March 14, 2001
CEOG-01-065

Subject: Transmittal of Approved Topical Report CE NPSD-1168-A, Rev 00

CE NPSD-
1168-A, Rev 00

Joint Applications Report for Containment Isolation Valve AOT Extension

Figure 13: Schematic of Penetration Connected to Charging Line -- Penetration Path E2

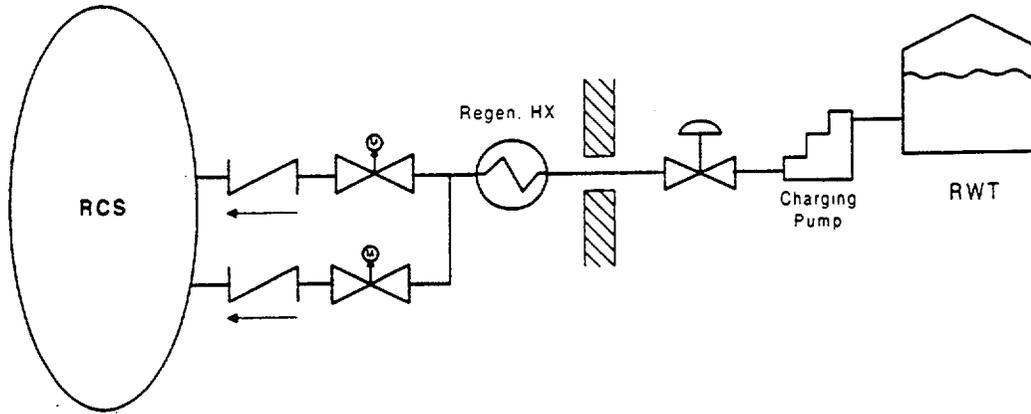
ID	Description of Penetration Flow Path	Calculation Method	Comment
E2	CIVs in penetrations used to provide charging under normal condition (See Figure 13)	No equations, qualitative assessment	Proposed by CEOG to be negligible and well below acceptance criteria of 5.0E-7 and 5.0E-8 for ICCDP and ICERLP respectively.
E3	CIVs in penetrations used to support containment heat removal function using containment sprays (See Figure 14)	$SAOT_{LRR} = \Delta CDF * P_{CK} * P_B * \frac{AOT}{8760}$ $= 5.83E-13$ <p>where</p> <p>$SAOT_{LRR}$ = single AOT risk for large early release</p> <p>ΔCDF = change in CDF, baseline CDF assumed to be: 2E-4/yr</p> <p>P_{CK} = probability of a pipe failing to isolate the associated containment penetration: 1.52E-3</p> <p>P_B = probability of a pipe failure in the open loop system outside the containment: 1.0E-4</p> <p>$\frac{AOT}{8760}$ = fraction of full duration of AOT (i.e., 168 hours) to a year</p>	<p>Specific Assumptions:</p> <ul style="list-style-type: none"> The containment penetration has one MOV outside and a check valve inside the containment where the MOV is the CIV that fails and is secured in the open position. Based on the previous assumption, a redundant means of isolating the containment will be lost during the AOT of 7 days. Random pipe failure outside the containment leads to the unavailability of the affected train of containment spray and a potential pathway to the environment. Mean probability of a check valve to close is 1.52E-3. <p>REVIEW COMMENTS:</p> <ul style="list-style-type: none"> In this case although the loop is open, the analysis effectively assumes a closed loop system by crediting other means of isolation as shown in term P_B. As in the case of E1, crediting close loop system as a barrier is applicable to cases in which the affected valve (the valve under CM) is intact.

ID	Description of Penetration Flow Path	Failure Mode	CDF Impact	LERF Impact
E2	<p>CIVs in these flow paths have varied functions: (1) safety injection, (2) make-up to RCS, and (3) support post accident heat removal. The penetrations are designed to be open in the event of an accident and some may be opened during normal plant operations.</p> <p>CIVs in penetrations used to provide charging under normal conditions. (See Figure 13)</p>	<p>Same as E1 above, except for the charging system (all high pressure). CIVs considered in either closed or open position.</p>	<p>CIV in the closed position removes system operability. However, the charging system is not always required for heat removal. In the open position, there would be little or no impact on CDF.</p>	<p>In the closed position, CIV would fulfill containment isolation function. In the open position because of high pressure design, there would be little or no impact on LERF.</p>

Figure 15: Schematic of Penetration Connected to Safety-Related Cooling Water Line -- Penetration Path E4

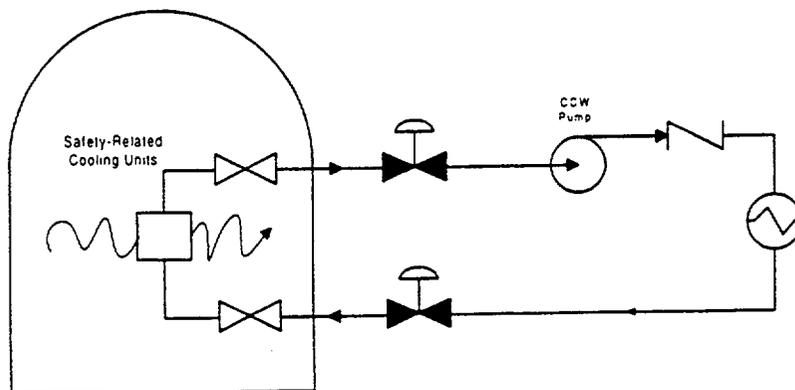
ID	Description of Penetration Flow Path	Calculation Method	Comment
E4	CIVs in penetrations used to support containment heat removal function using fan coolers (See Figure 15)	$SAOT_{trial} = ACDP \cdot P_f \cdot P_H \cdot AOT$ $= 2.30E-13 \text{ for closed loop}$ $= 3.84E-10 \text{ for open loop}$ where $SAOT_{trial}$ = single AOT risk for large early release $ACDP$ = change in CDF, baseline CDF assumed to be: $2E-4/yr$ P_f = probability of a pipe failing to isolate the associated containment penetration: $1.0E-4$ P_H = probability of a pipe failure in the closed loop system outside the containment: $6.0E-4$ (closed loop), or 1.0 (open loop) AOT = fraction of full duration of AOT (i.e., 168 hours) to a year 8760	<p>Specific Assumptions:</p> <ul style="list-style-type: none"> The containment penetration has a MOV on the outside and a normally open manually operated valve inside the containment where the MOV is the CIV that fails and is secured in the open position. Only a random piping failure can establish a pathway from containment to the environment with a conditional probability of $1.0E-4$ during the proposed AOT. Inadvertent opening of a relief valve will also breach the piping outside of containment and is given a probability of $5.0E-4$ for the proposed AOT. A breach in the piping of both inside and outside containment must fail for a pathway to the environment. Securing the MOV in the closed position will result in an action per TS. The proposed AOT for an inoperable CCS cooling water line CIV is 7 days. <p>REVIEW COMMENTS:</p> <ul style="list-style-type: none"> The unaffected CIV is assumed to be OPERABLE. Crediting close loop system outside containment as a barrier is applicable to cases in which the affected valve (the valve under CM) is intact. If not true, the value of $SAOT_{trial}$ would increase by approximately three orders of magnitude.

E4	<p>CIVs in these flow paths have varied functions: (1) safety injection, (2) make-up to RCS, and (3) support post accident heat removal. The penetrations are designed to be open in the event of an accident and some may be opened during normal plant operations.</p> <p>CIVs in penetrations used to support containment heat removal function using fan coolers. (See Figure 15)</p>	<p>CIVs in this system provide for containment cooling function.</p> <p>CCS – CIV secured in closed position renders system inoperable for cooling. In the open position a barrier loss results, and impacts the protection against containment bypass.</p>	<p>CIV in closed position renders system inoperable for cooling and would impact the CDF through reduced cooling capability. On the other hand, a secured open CIV leads to the loss of one barrier.</p>	<p>A secured closed CIV would impact LERF due to reduced heat removal capability affecting long term containment integrity. On the other hand, a CIV in the secured open position would lead to a containment bypass path contributing to the release of radioactive materials.</p>
